Reg.12-10/A.12-10-009
SDG&E CNF PTC Application

Subject: CNF ED11-SDGE Response – Questions 1-6.

ED11-SDGE 05/15/2015 Response
A.12-10-009 Cleveland National Forest (CNF) Power Line Replacement Projects PTC
ED Data Request 11 Dated May 8, 2015
ED11-SDGE: Question 1-6

C78 - P166377

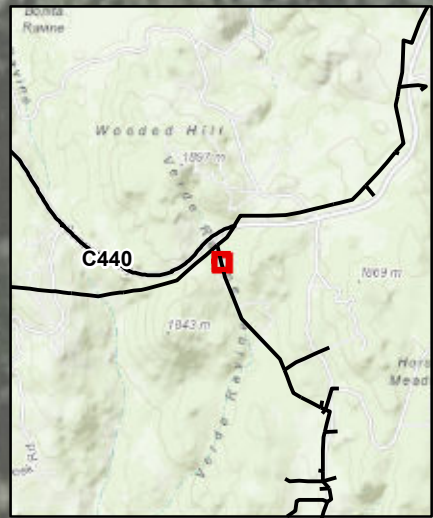
Table D.4-10 (Exhibit B in DR10) shows < 0.01 acre of temporary and/or permanent impact acreages to U.S. Army Corps of Engineers-jurisdictional waters for the following project lines: C78, C157, C442, C440, and C449. Please clarify where these impacts to ephemeral drainages occur along these lines. Please include the pole numbers where impacts occur.

The GIS database provided as part of SDG&E’s response to ED Data Request 10 includes all necessary data where work areas may have temporary or permanent impacts to jurisdictional waters for the five 12 kV distribution lines. Many of these areas are the result of very minor GIS layer overlapping; some locations have small drainages located alongside or to one side of the pole work area polygon. As described in SDG&E’s Revised POD, these work areas will be delineated prior to construction to avoid such impacts to the extent possible. The following table provides the identified permanent and temporary impacts to these features by distribution line and pole number, as well as the amount of impact to the hundred-thousandths of an acre. Also attached is a mapset showing the location of these identified features, the pole work area polygon, and associated pole and distribution circuit number.

Permanent Impact (acres)	Temporary Impact (Acres)	Total (Acres)
C78			
P166377		0.00021	0.00021
C440			
P40126		0.00021	0.00021
P40127		0.00045	0.00045
P40128		0.00002	0.00002
P40136		0.00040	0.00040
P40199		0.00038	0.00038
P40452	0.00004	0.00052	0.00056
P45116		0.00025	0.00025
C442			
P178030		0.00003	0.00003
P178039		0.00018	0.00018
